ST. TAMMANY PARISH

Addendum No.: 1

Bid#: 24-43-2

Project Name: Brewster Road Sewer Consolidation

SHEET NO.
10PP-09

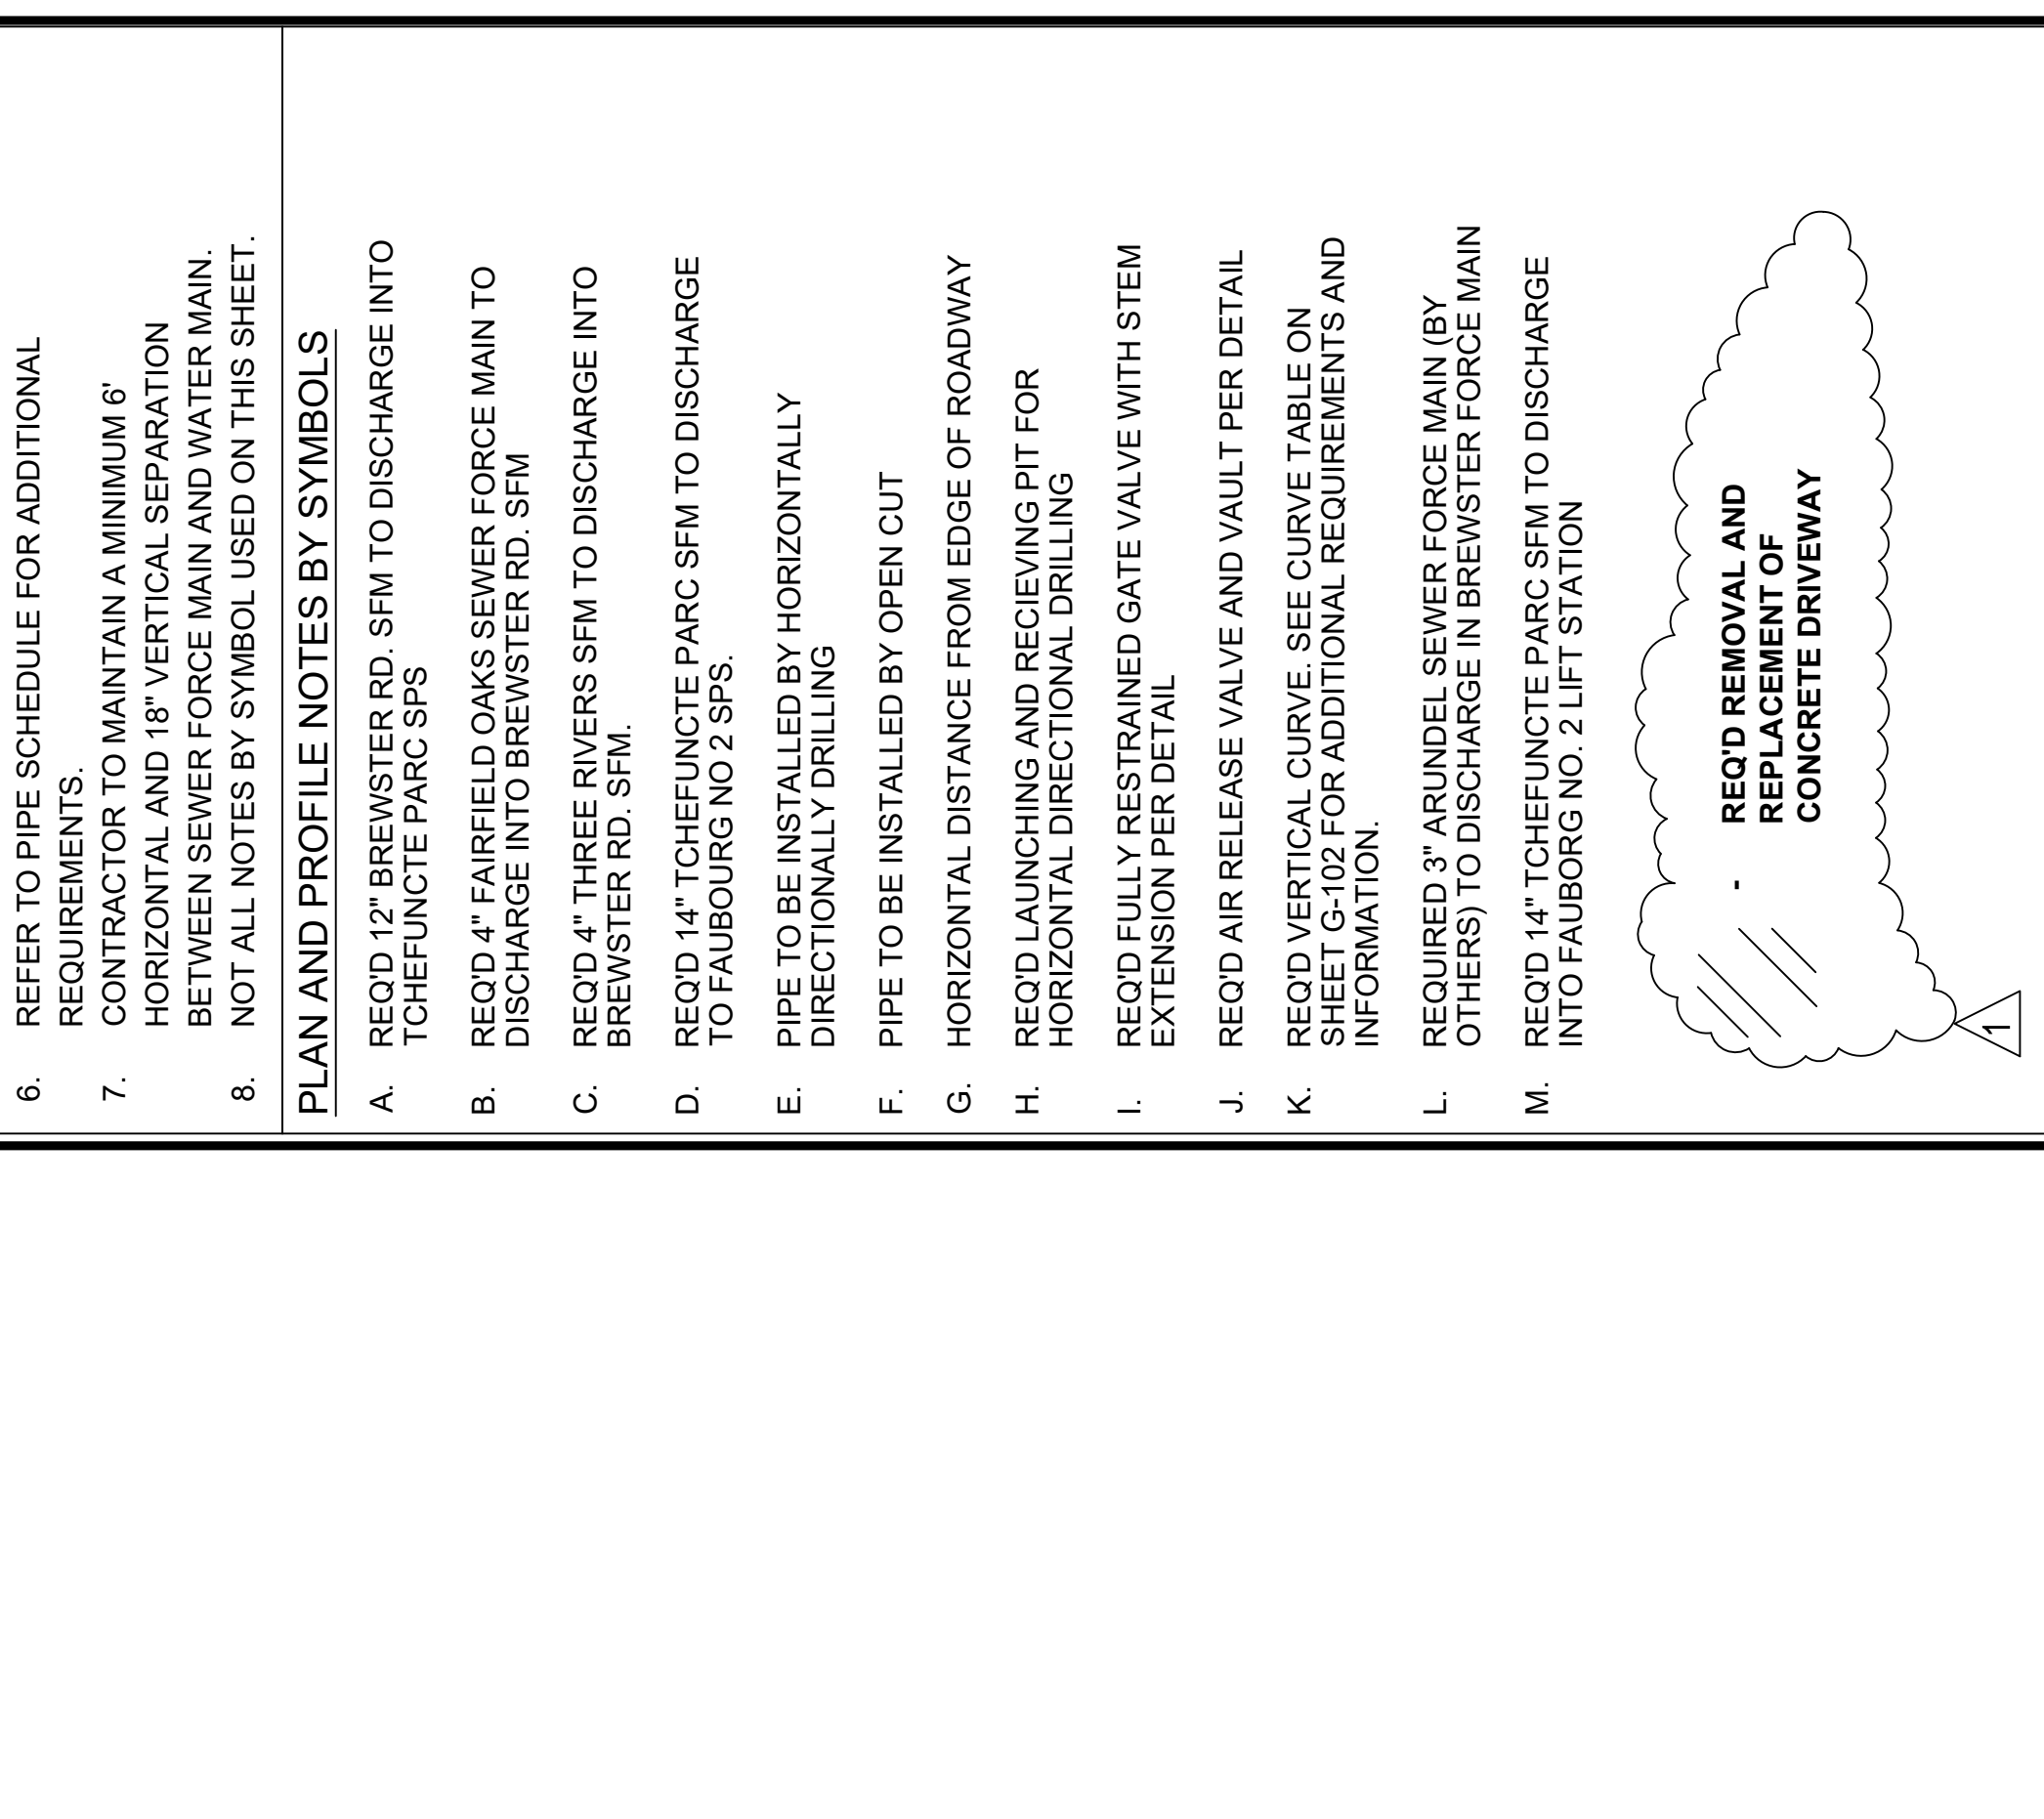
- c. DELETE Drawing 10PP-07 and REPLACE with the attached REVISED Drawing 10PP-07.
 - d. DELETE Drawing 10PP-09 and REPLACE with the attached REVISED Drawing 10PP-09.

SHEET NO.
20PP-03

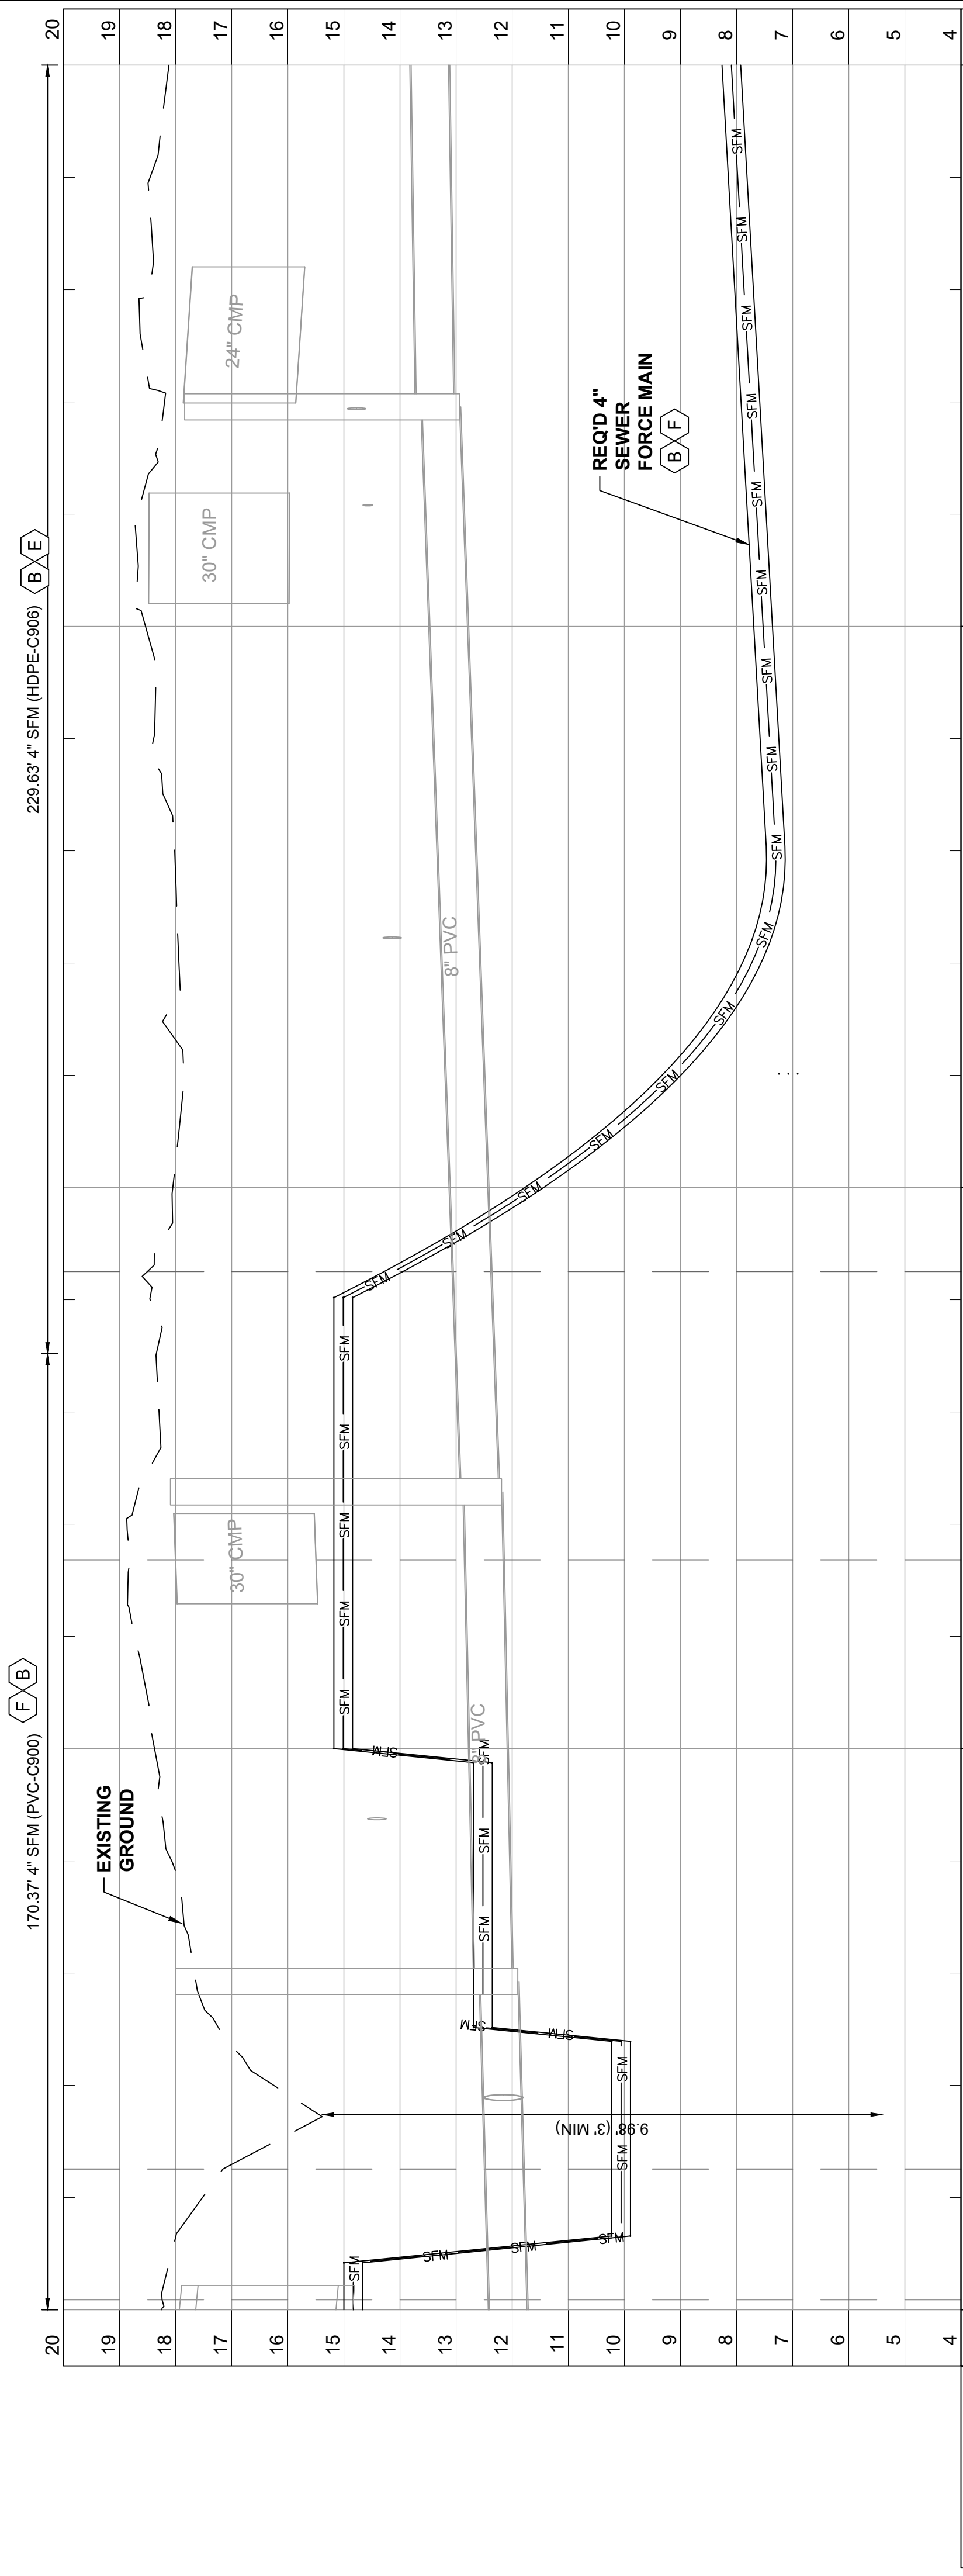
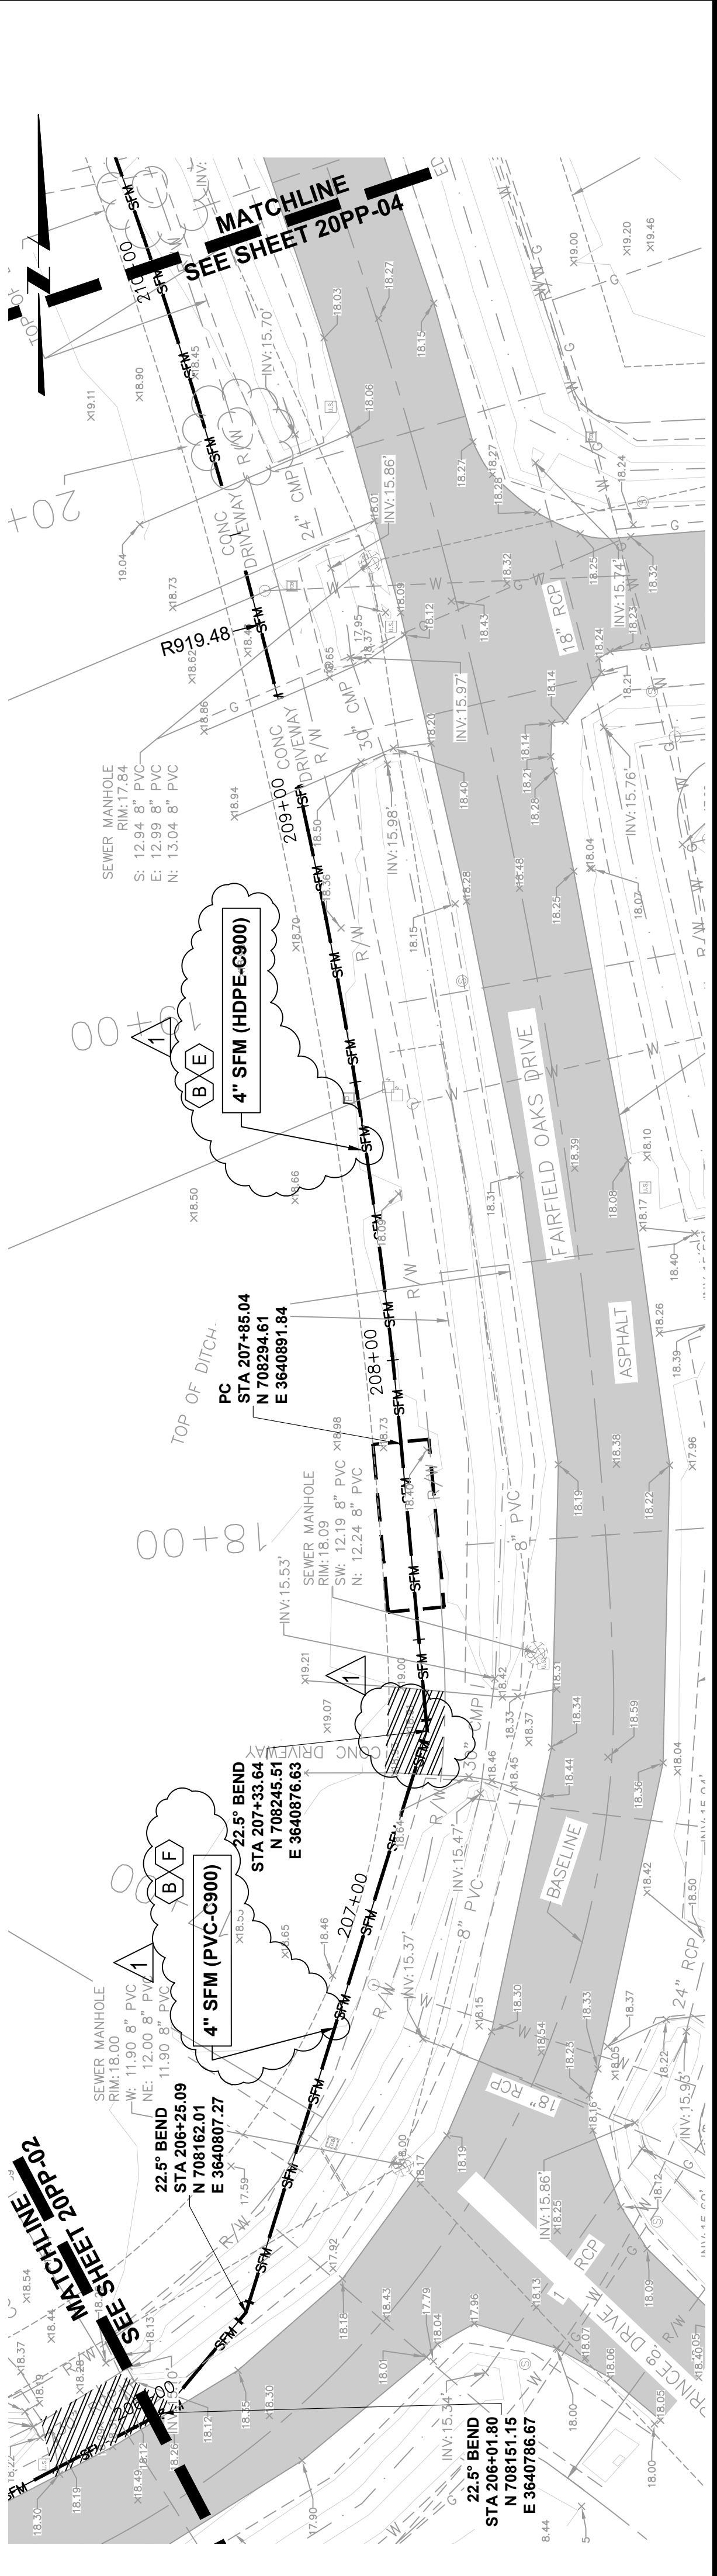
- e. DELETE Drawing 20PP-02 and REPLACE with the attached REVISED Drawing 20PP-02.
- f. DELETE Drawing 20PP-03 and REPLACE with the attached REVISED Drawing 20PP-03.
- g. DELETE Drawing 20PP-04 and REPLACE with the attached REVISED Drawing 20PP-04.
- h. DELETE Drawing 20PP-05 and REPLACE with the attached REVISED Drawing 20PP-05.
- i. DELETE Drawing 30-03 and REPLACE with the attached REVISED Drawing 30PP-03.
- j. DELETE Drawing 40PP-02 and REPLACE with the attached REVISED Drawing 40PP-02.
- k. DELETE Drawing 40PP-03 and REPLACE with the attached REVISED Drawing 40PP-03.
- l. DELETE Drawing 40E-02 and REPLACE with the attached REVISED Drawing 40E-02.
- m. DELETE Drawing 40E-04 and REPLACE with the attached REVISED Drawing 40E-04.
